Development Referral No. DN25/0020

Proposal: Notification of Modification Application Kurnell Refinery Conversion Project SSD 5544 MOD 7

Property: 160-166 Captain Cook Drive, Kurnell

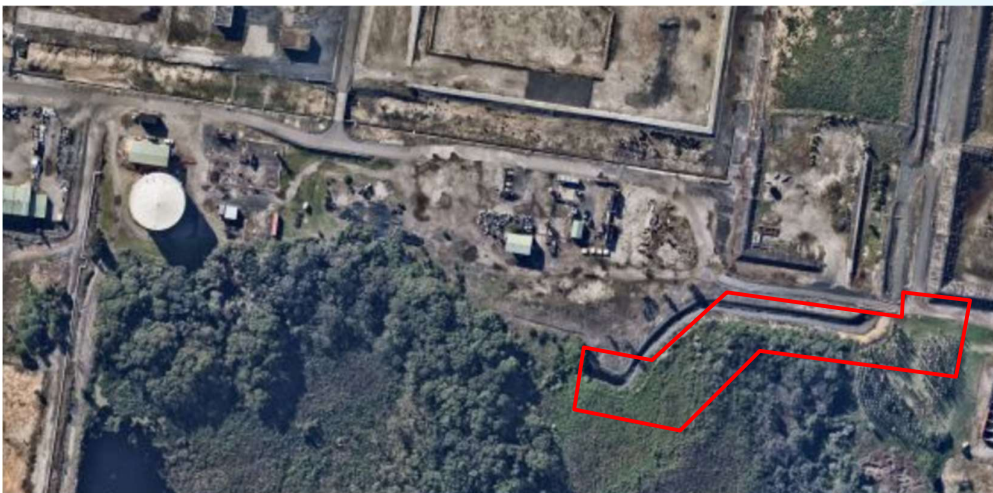
- As detailed in council's submission for the BESS and the subdivision Scoping Report, a review of aerial photography has revealed that a large rock lined stormwater channel has been constructed without any approval – refer to map extract below and the red highlight. This channel has been constructed in an area mapped as being a wetland pursuant to SEPP Resilience and Hazards 2021.

The future development of land must not rely on the unauthorised drainage channel for any stormwater disposal and the like. Ideally, the channel and all associated works must be removed and the land restored to pre work conditions. A long-term vegetation and land restoration management plan should accompany any future application for the restoration of the wetland environment.
